REMARKS

Drawings

FIG.1

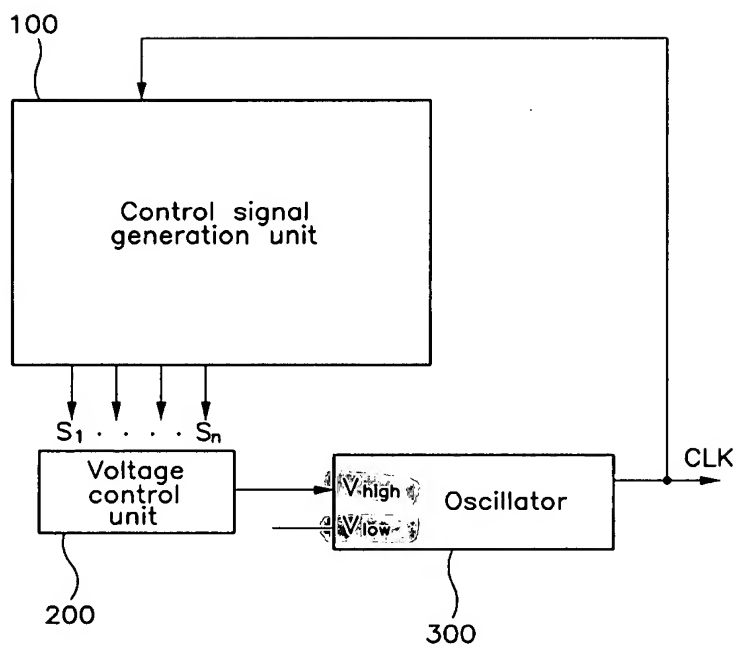
The Examiner objected the drawings. In FIG. 1 the Examiner objected the labeling “V_{high}” and “V_{low}”. The Examiner suggested the labeling V_{high} and V_{low}.

In response, Applicant introduced the suggested labeling in amended FIG. 1.
